**Response to the Notice of Disapproval for the Investigation Report for
DP Site Aggregate Area Delayed Sites and DP East Building Footprints at TA-21,
Los Alamos National Laboratory (LANL), EPA ID No: NM0890010515, HWB-LANL-11-097,
Dated January 18, 2012**

Figure 1 Comparison of planned versus actual sampling location 42 at former building 21-155

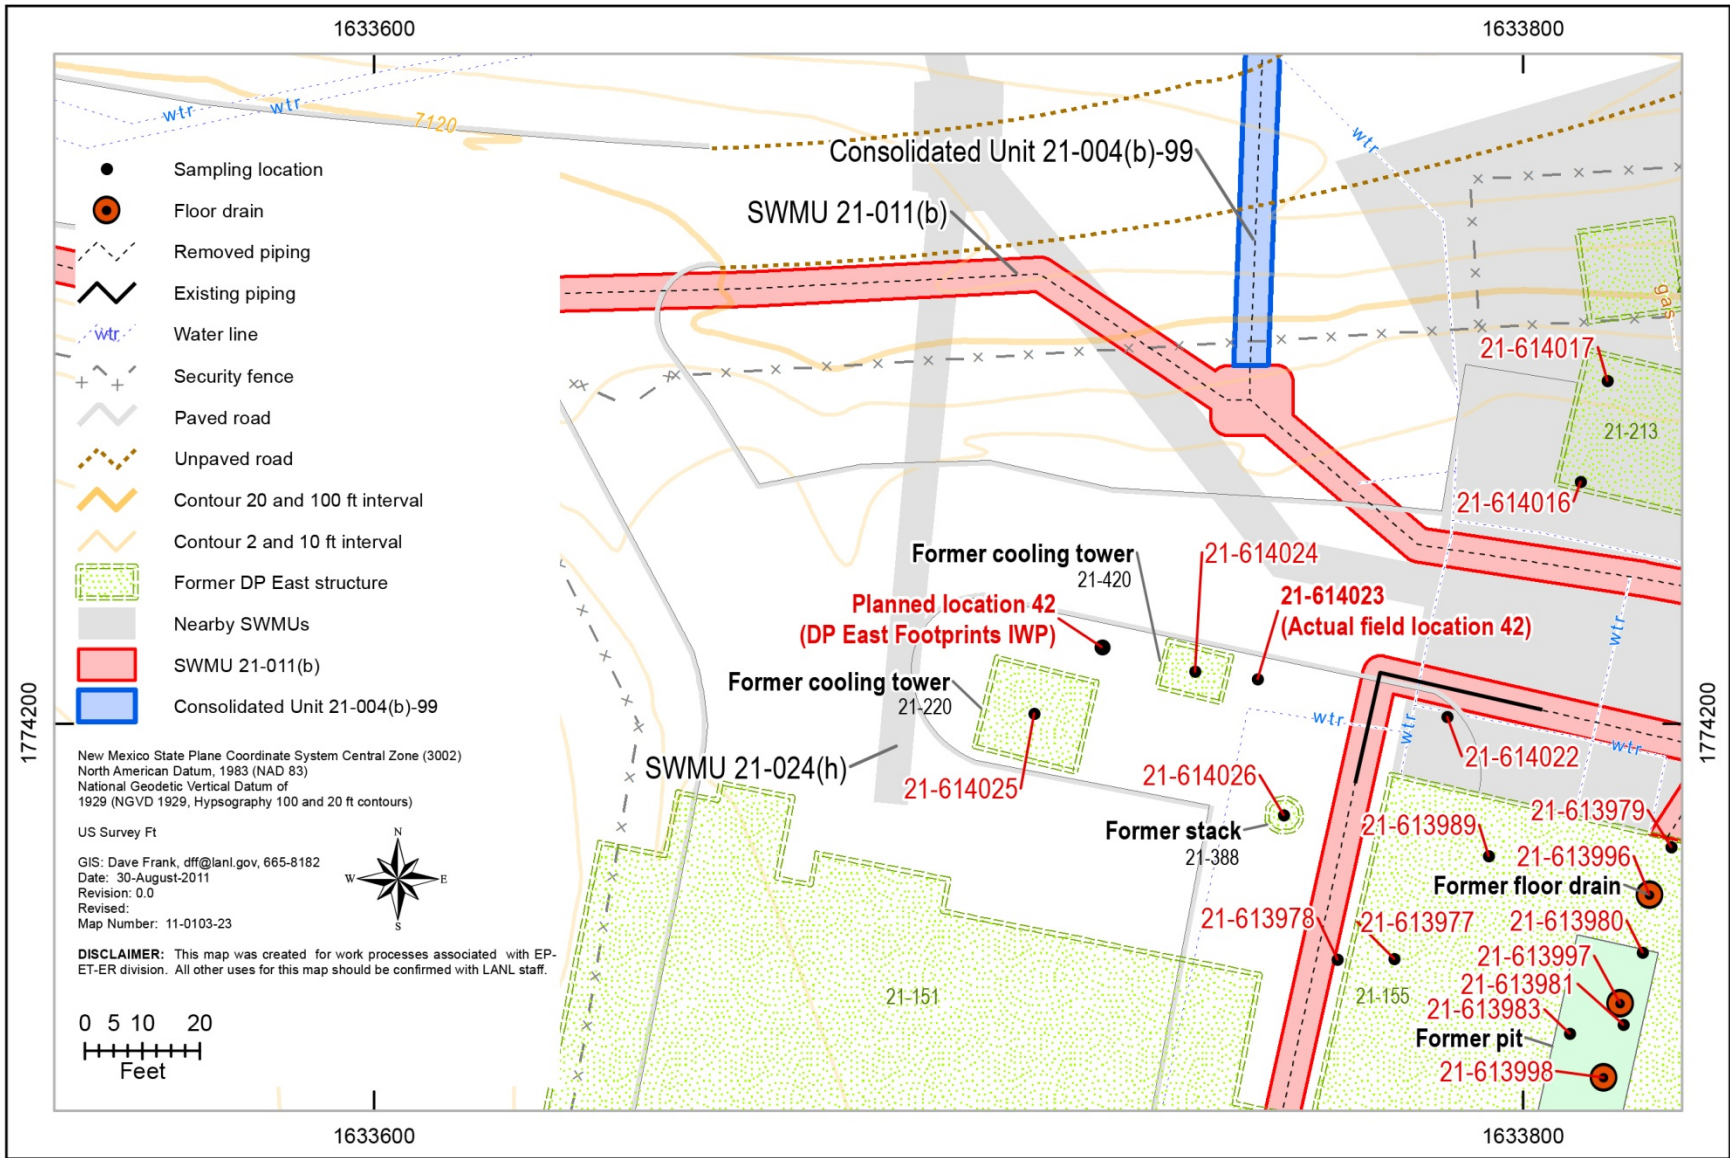
5. Section 4.3, Deviations, Former Building 21-155, page 21

NMED Comment: Sample location 42 shown on Figure 2.2-1 of the Footprint WP was apparently relocated to location 21-614023 shown on Figure 2.5-1 of the IR. This location was chosen to sample below cooling tower 21-220 piping, but was relocated approximately 30-ft to the east and below cooling tower 21-420 piping. This change was not listed in the Deviation section, or any other place in the IR, and no explanation was provided for the deviation from the approved Footprint WP. The Permittees must discuss this change in the Deviation section and must propose to collect samples at the original location 42 in the Phase II Work Plan.

5. A sample should have been collected at location 21-614023 west of location 21-614024, not east of location 21-614024 (attached Figure 1 shows the deviation). Table 4.2-1 has been updated to indicate the incorrect area was sampled. This information has also been added to the deviations (section 4.3) as the last bullet under the section titled "Former Building 21-155" (p. 21). The appropriate sampling location will be included in the Phase II investigation work plan.

Figure 2 Sampling locations under inlet and outlet lines at former sump 21-223

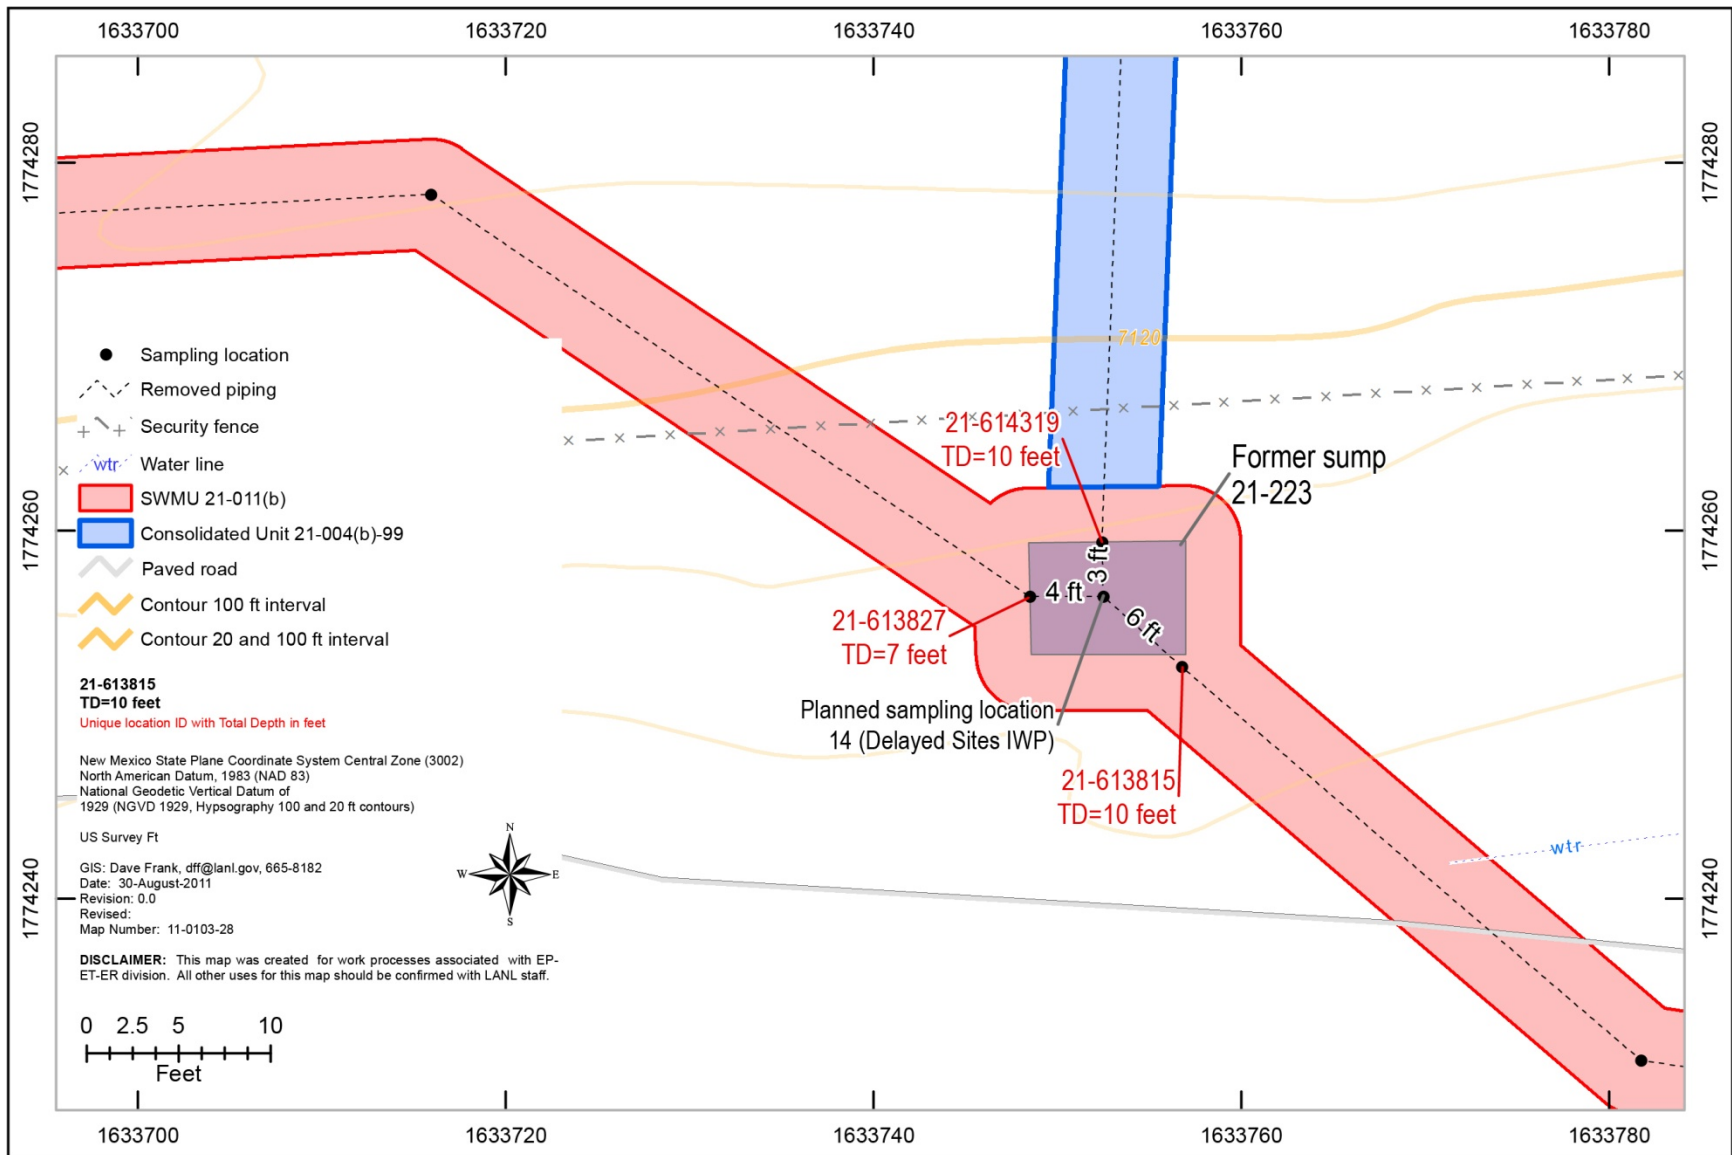
8. Section B-8.0, Deviations from the Work Plans (SWMU 21-011(b)), page B-5, bullet 3

Permittees' Statement: "Sump structure 21-223, which extended at least 15 ft belowgrade, was demolished to below 10 ft belowgrade. The remaining lower portion of this cast-in-place sump was poured against competent tuff bedrock. Because of the sump's location on a relatively steep sloping site area, the presence of active fire water lines on parts of two sides of the excavation, and a nearby power pole, the Laboratory's site engineer determined that complete removal of the sump was impracticable; at the direction of the Laboratory's subcontractor technical representative, it was left in place. The remaining portion of the sump was filled with bentonite and soil before the excavation was filled to grade with clean soil. This did not prevent planned sample collection at the site."

NMED Comment: Planned sample collection included Location 14 from Table 5.2-1 and Figure 4.1-1 of the approved Delayed Sites IWP. These samples were not collected and no explanation was provided to justify their omission. The Permittees must propose to sample below Sump structure 21-223 in the Phase II IWP.

8. Samples were collected at locations 21-613815, 21-613827, and 21-614319 in the area of the sump (structure 21-223) at the inlet and outlet lines (see attached Figure 2). The sump foundation appeared fully intact and was formed within the tuff. The samples to be collected from under the sump could not be collected because the concrete foundation had formed within the tuff at depths greater than 10 ft bgs. This information has been added to section 4.3, Deviations, and to section B-8.0 in Appendix B. Additional sampling to depths below the sump structure will be proposed in the Phase II investigation work plan.
